Request for Information Docket No. CWA-IR-17-015

Compliance Evaluation Inspection Mid-Point Park WWTP

Compliance Evaluation Inspection: Midpoint Park SD WWTP Royal Ridge, Wappingers, NY

IMG_4602 - Final Clarifier - some uneven flow over the weirs

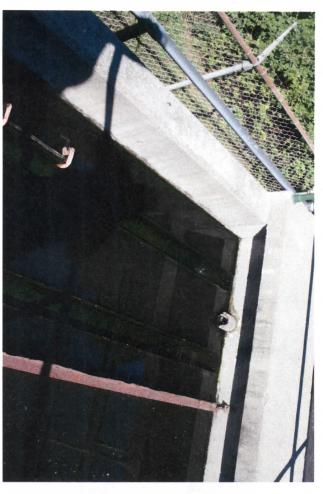
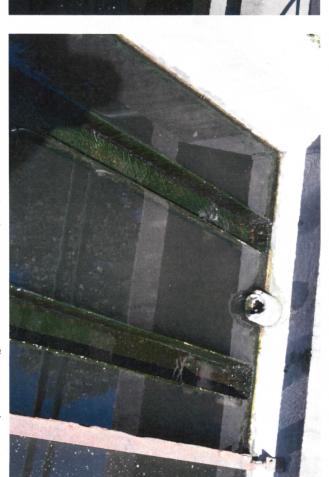
- 5. As shown in photos 602 and 603 there was some uneven flow over the final clarifier weirs. Clarifier weirs must be kept plum to ensure even flow and avoid short circuiting in the clarifiers. Facility representatives indicated that new plastic weirs were to be installed. What is the status of the installation of the new weirs?

IMG_4607 - operating sand bed (No. 1) — uneven distribution

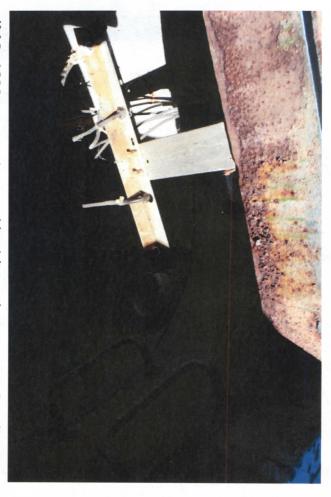
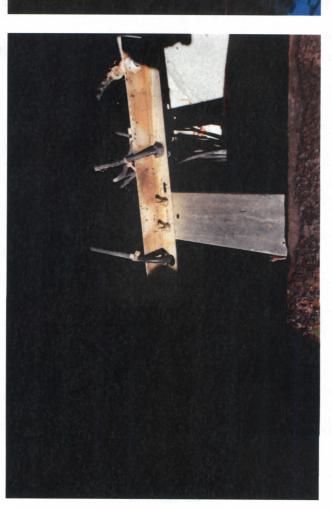
- 7. As shown in photos 604 to 607 sand bed there was uneven distribution of flow/ponding in Sand Bed No. 1. Sand bed No. 2 was said to not be in operation. Facility representatives said that they planned on getting new sand in 2017. What is status of placing new sand in beds.
